Subject: Zion Station Units 1 and 2
Additional Fire Protection Information
NRC Docket Nos. 50-295 and 50-304

Response to Items in Enclosure 5 of the
March 24, 1980 letter from A. Schwencer to
D. L. Peoples

ATTACHMENT 2
ZION 1 & 2 POWER CABLE REROUTING

NORTHWEST QUADRANT
UNIT 1 CONTAINMENT
ELEVATION 568'

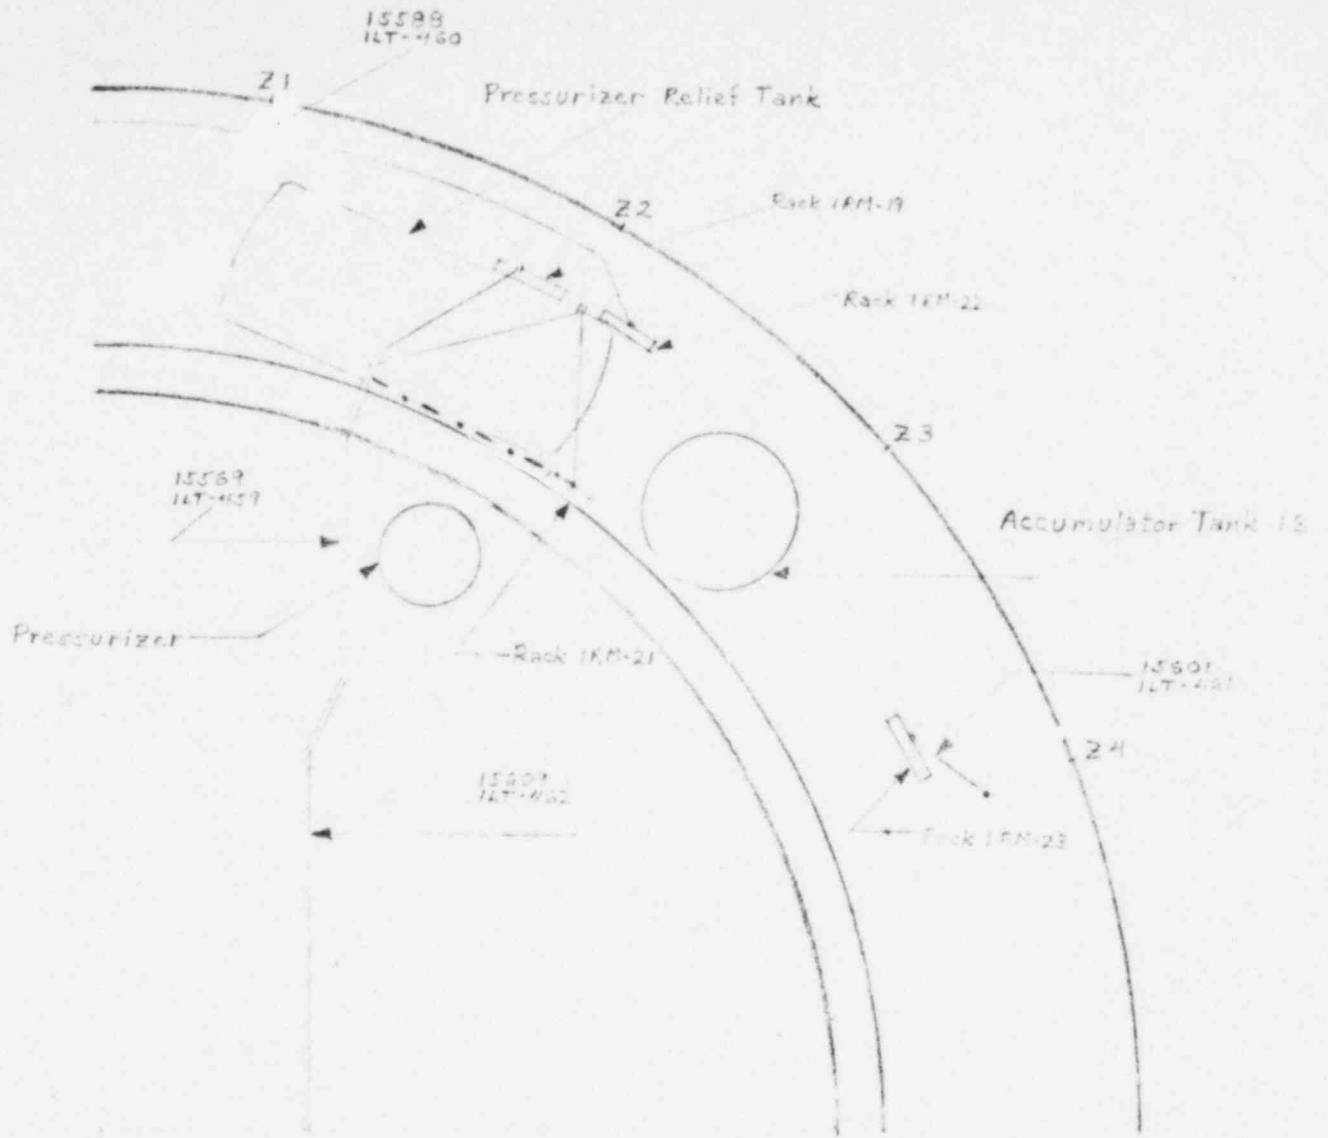
Cable 15609 (channel LLI-462) from Rack RM-21 is presently routed near Racks RM-19 and RM-22 (see accompanying sketch). This cable will be rerouted (dotted line on sketch) along the missile barrier behind the pressurizer relief tank to reduce the possibility that a postulated fire could affect more than two channels of pressurizer level signals. An extension of the fire barrier at the penetration area will be constructed to assure that pressurizer level indication will remain available in case of a postulated fire. Since two channels of pressurizer level signals approach the penetration area from the north and the other two channels approach from the south, the extended fire barrier will prevent the loss of more than two channels of pressurizer level signals. This separation will be identical to that currently provided in the penetration vaults outside containment.
